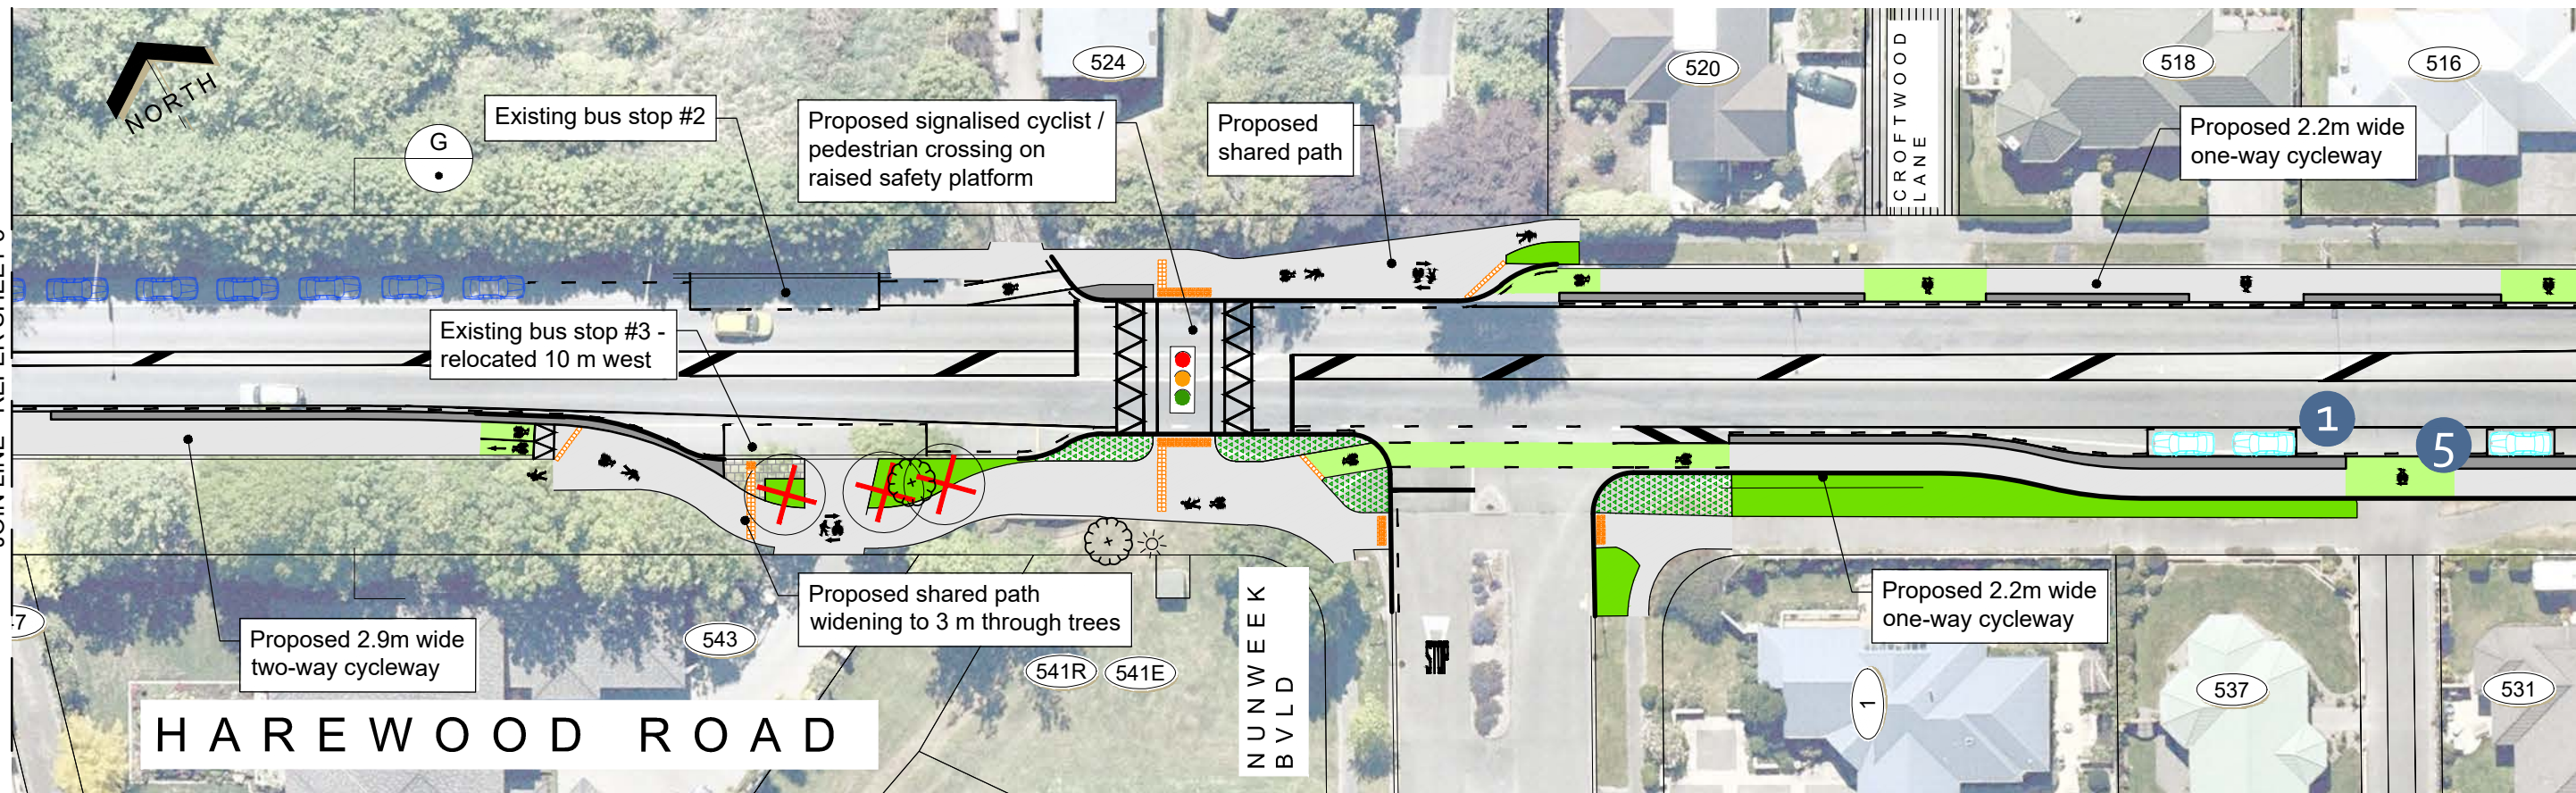
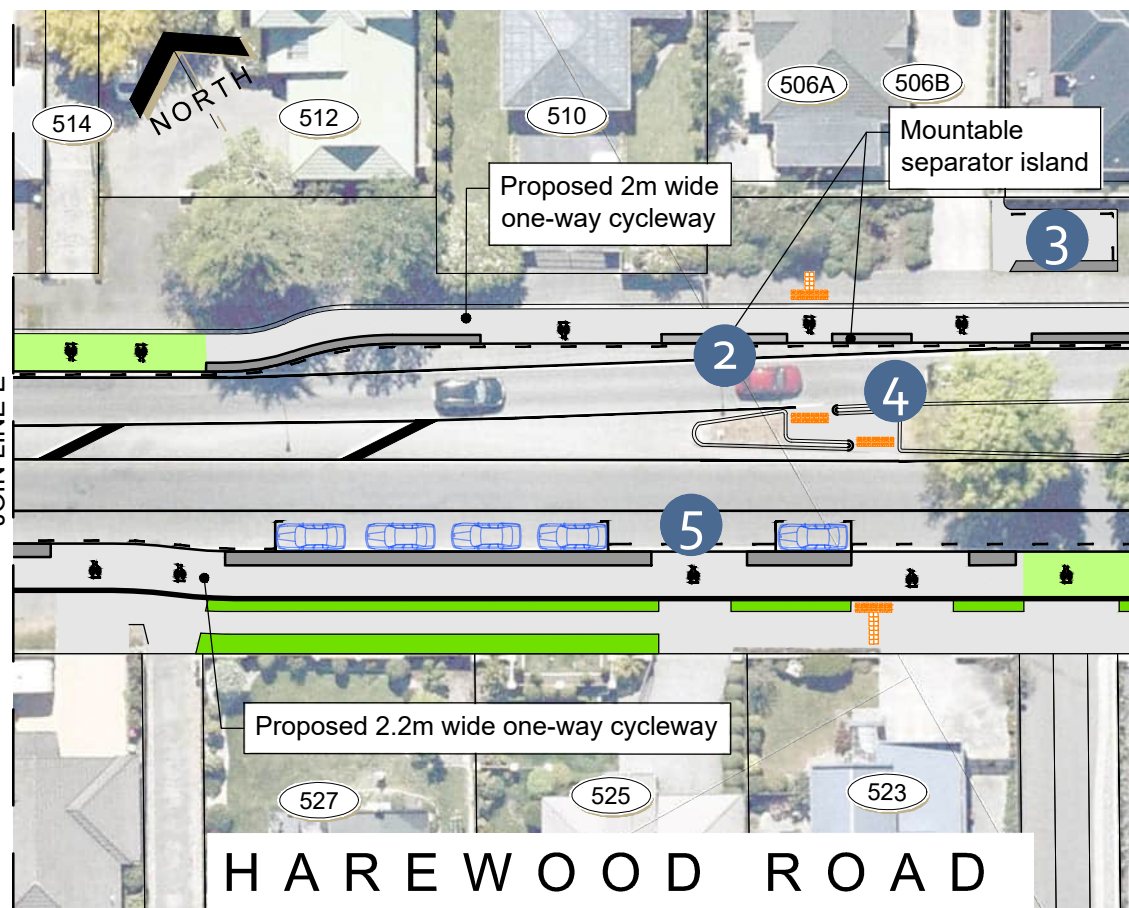
Proposed design changes following consultation:

- 1 The cycleway separator is realigned and three on-street parking spaces are added.
- 2 The cycleway separator outside No. 506 is made mountable so that residents can drive over it when performing a U-turn to enter their driveway.
- 3 A turning area is added for residents of No. 506 who have less manoeuvre space due to the location of the central median island.
- 4 The crossing through the central median is widened to make it easier to use.
- 5 The openings in the cycleway separator at driveways between Nunweek Boulevard and the roundabout are increased to a minimum 5.5 m long.

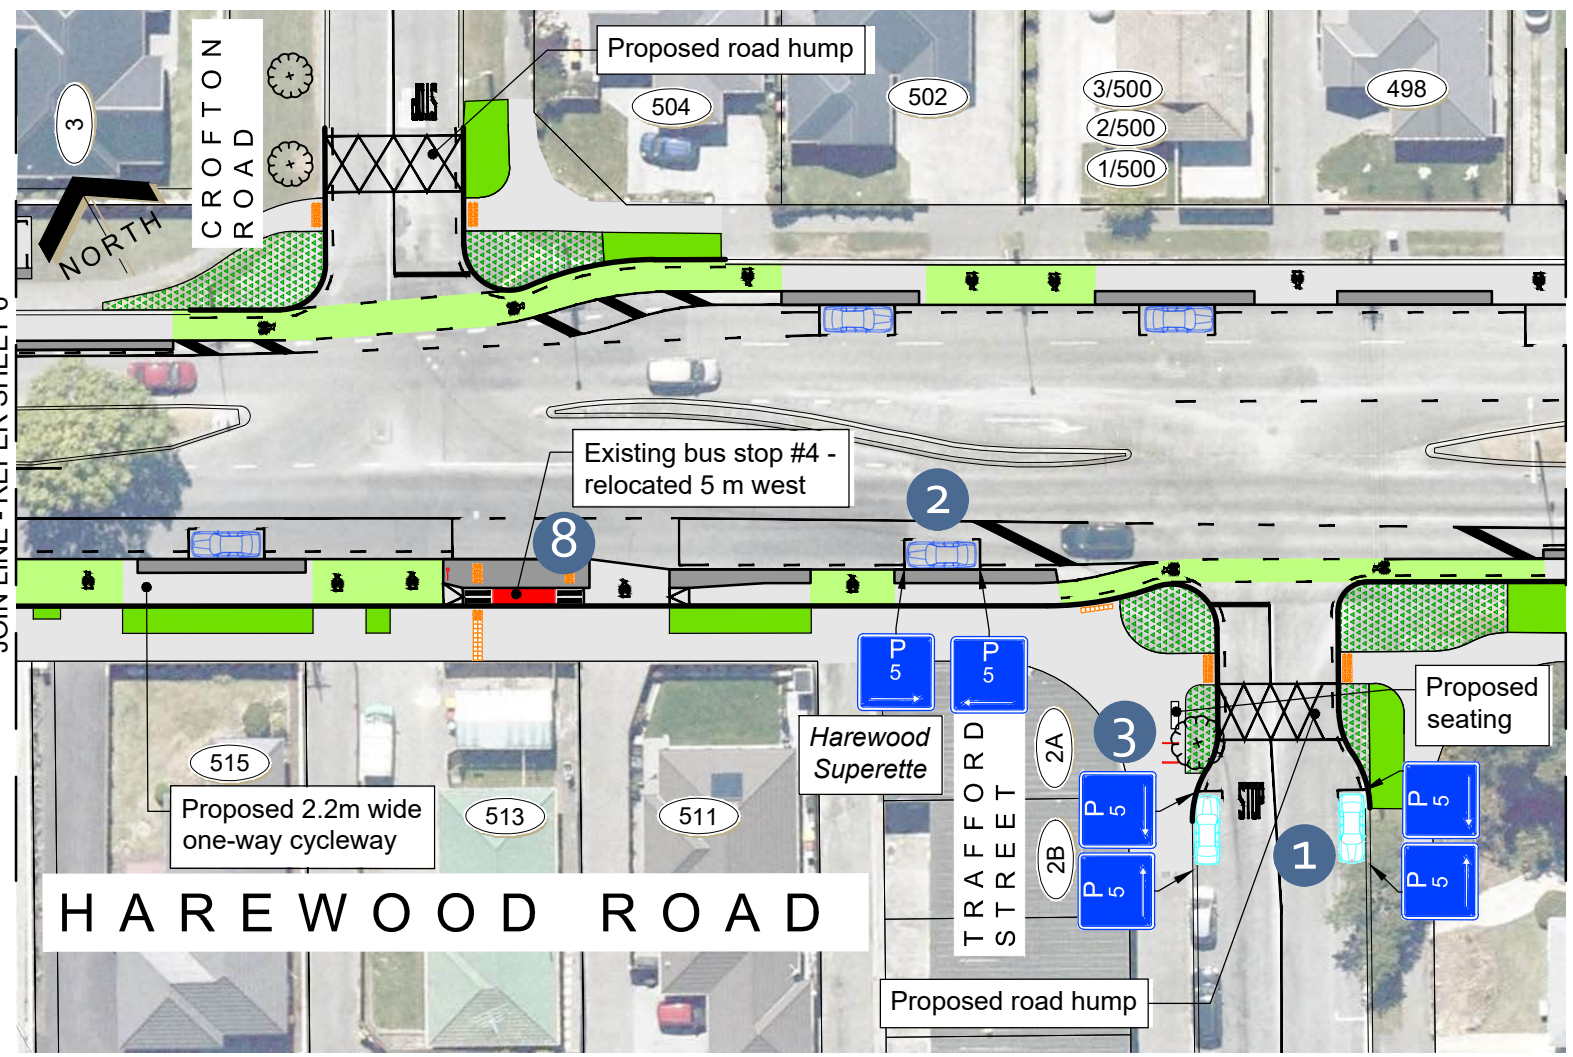
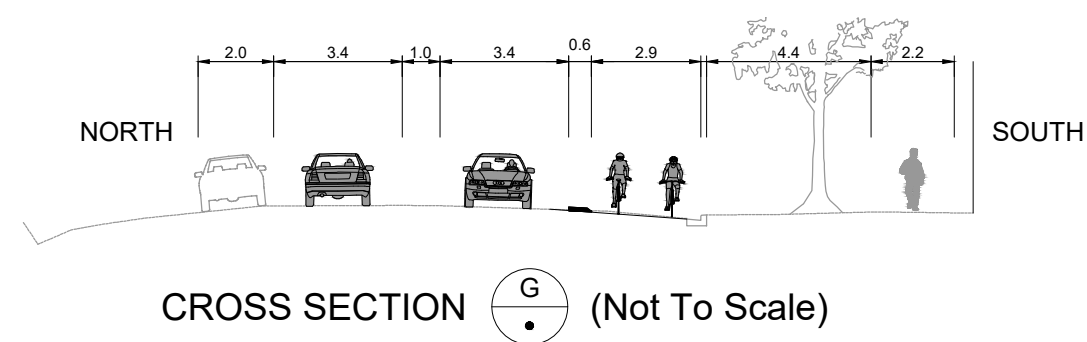
- Proposed design changes following consultation:**
- 1 Two additional on-street parking spaces are provided on Trafford Street, both designated P5.
 - 2 The P5 parking space on Harewood Road is shifted closer to Trafford Street. The bus stop is shifted to 5 m west of its existing location.
 - 3 The old cycle stand outside the Trafford Street shops is replaced with new stands.
 - 4 The cycleway outside the bakery is realigned, narrowed and raised to footpath height. This gives more spaces for vehicle access and makes it easier to cross on foot.
 - 5 The vehicle entrance into Copenhagen Bakery is shifted to the east, providing one more on-street parking space and allowing the carpark to be reconfigured to make the spaces easier to access.

- 6 An additional on-street parking space is provided outside No. 405 Harewood Road.
- 7 The design of the pedestrian crossing point outside No. 423/444 is changed to provide two additional on-street parking spaces, one on each side of the road.
- 8 The platforms for the bus stops outside No. 496 and No. 513 Harewood Road are widened to approximately 1.8m. The cycleway is narrowed at these locations.
- 9 Three additional on-street parking spaces are provided on Harewood Road approaching Gardiners Road. These are not available for use during 3pm-6pm, when left-turning traffic volumes are higher. The spaces are designated P60.

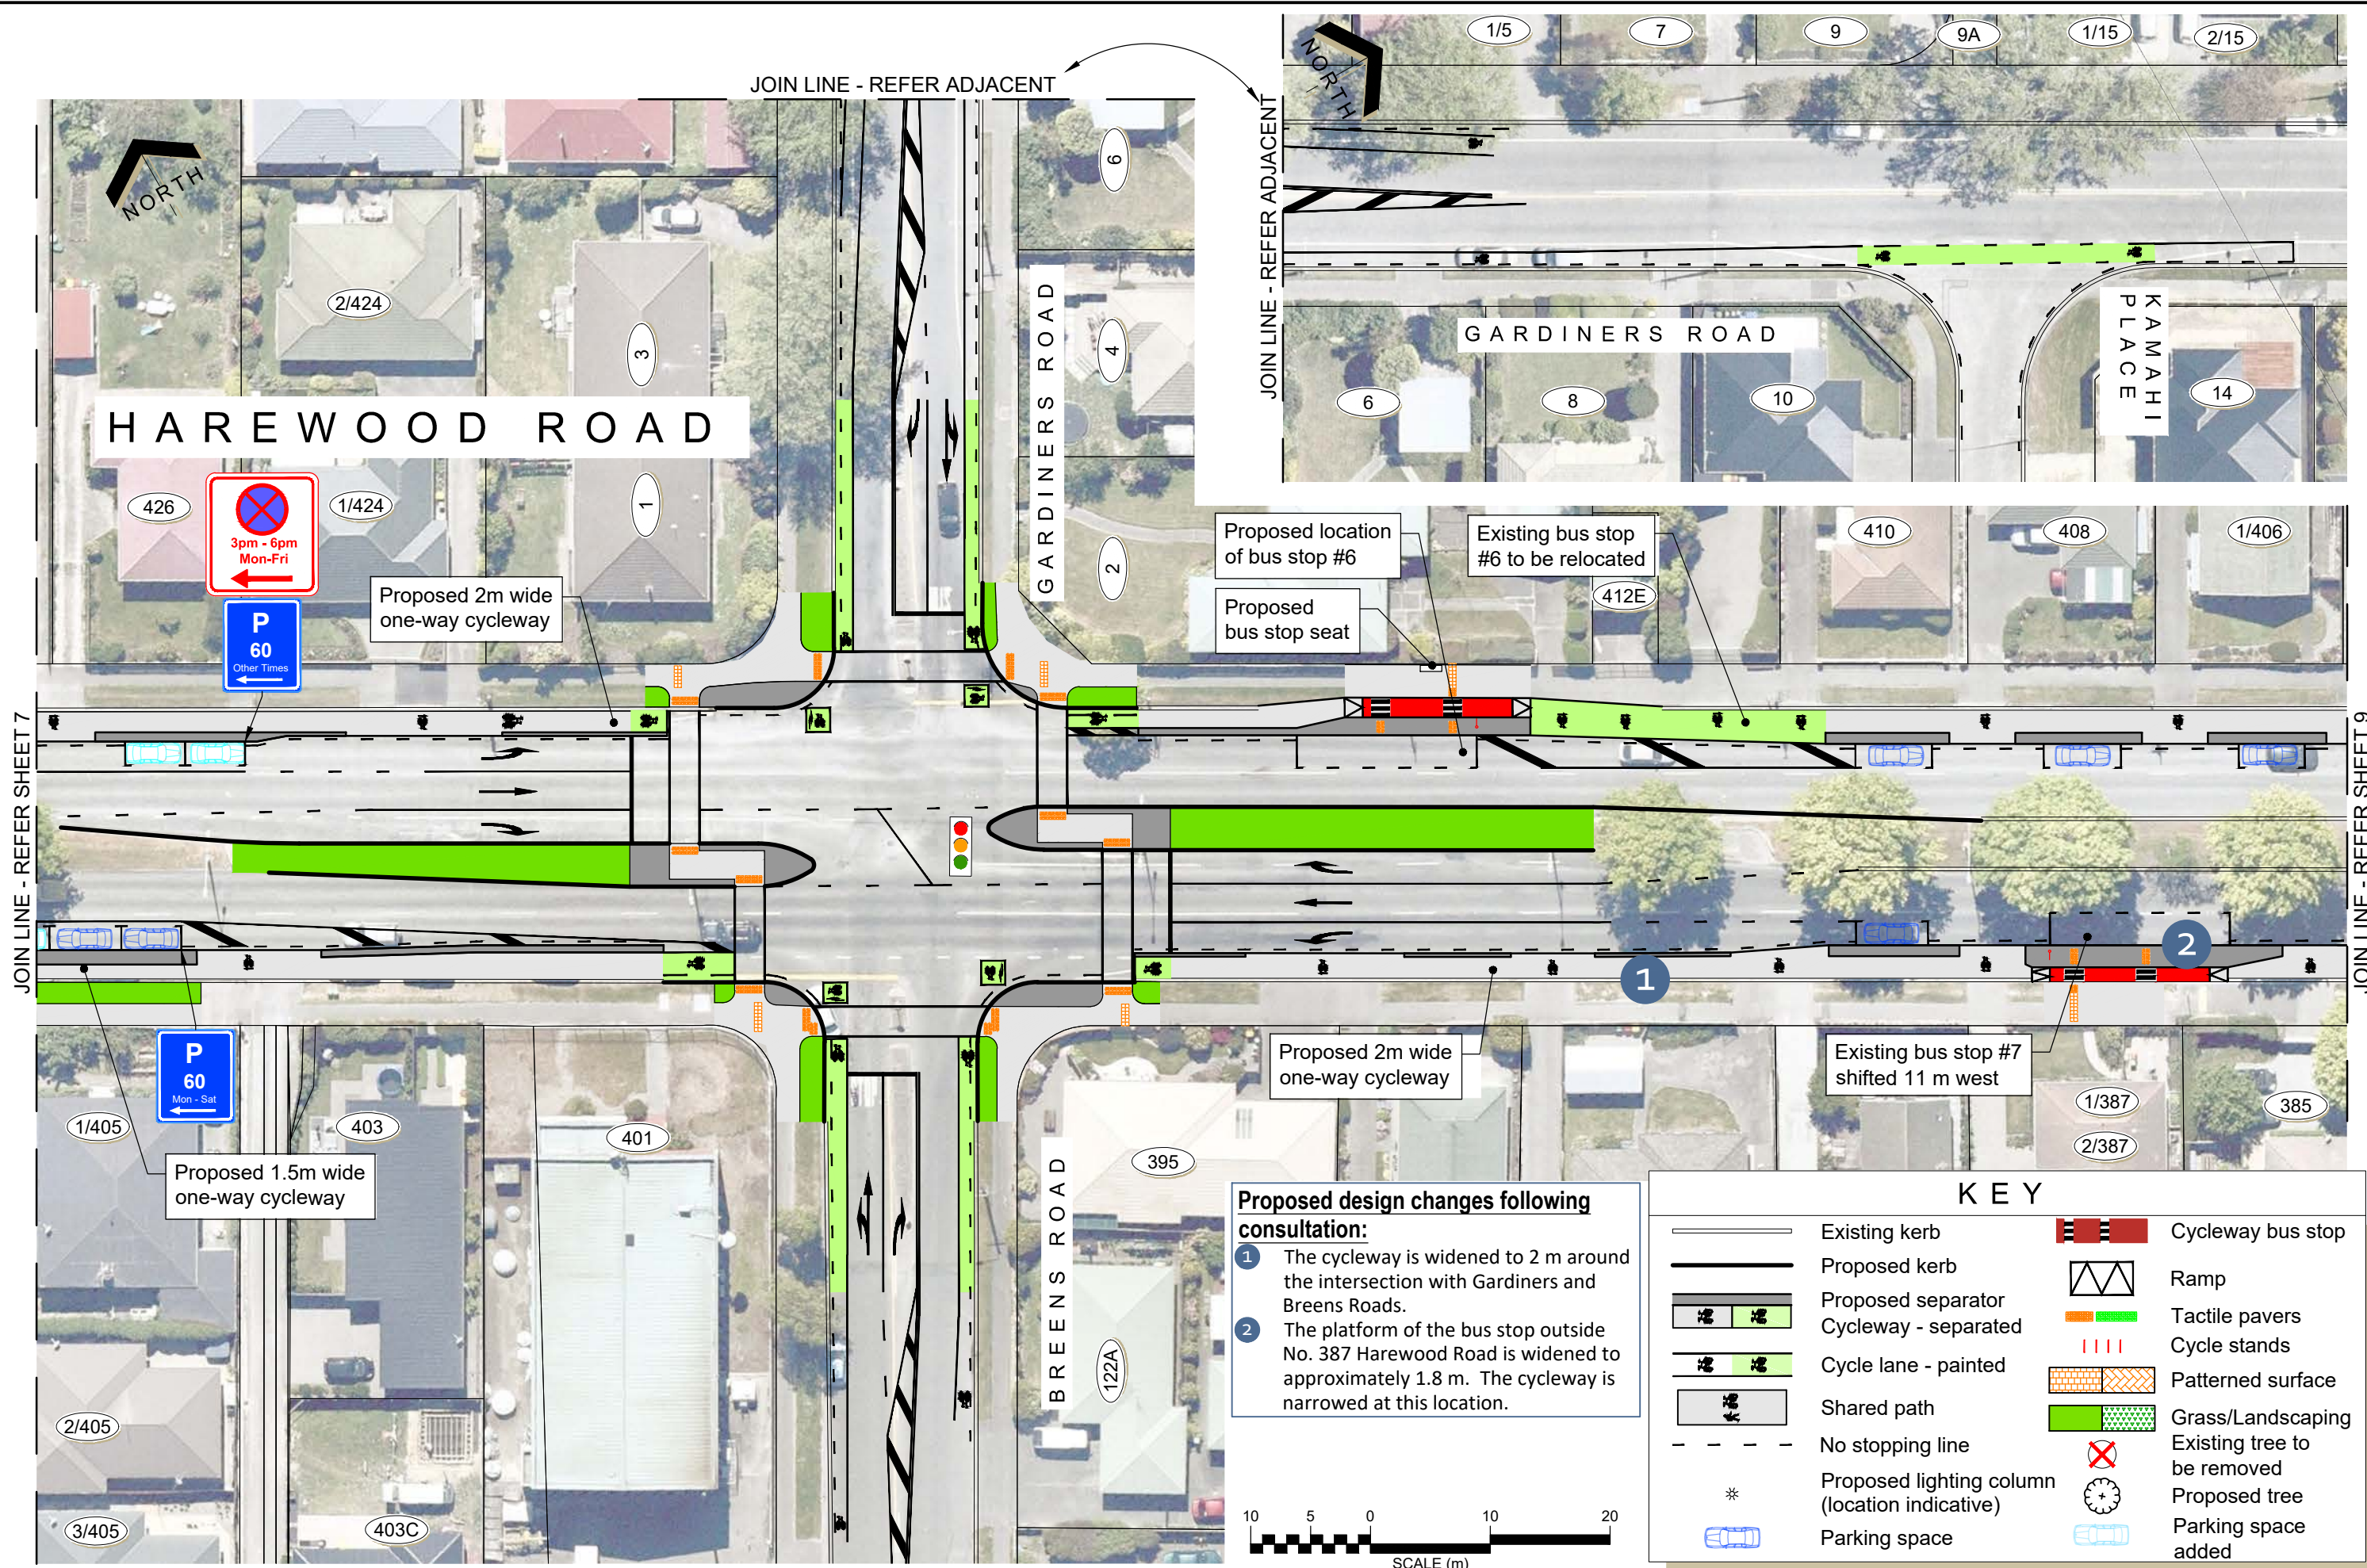
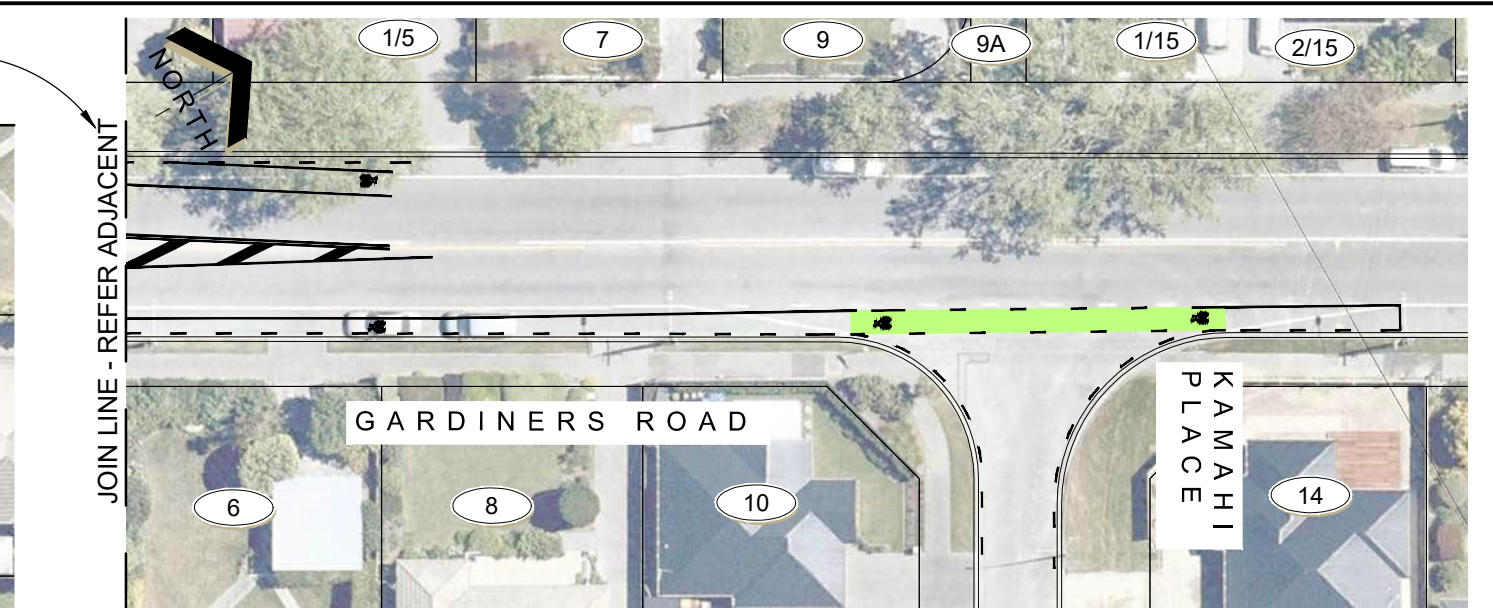
Proposed design changes following consultation:

- 1 The cycleway is widened to 2 m around the intersection with Gardiners and Breens Roads.
- 2 The platform of the bus stop outside No. 387 Harewood Road is widened to approximately 1.8 m. The cycleway is narrowed at this location.
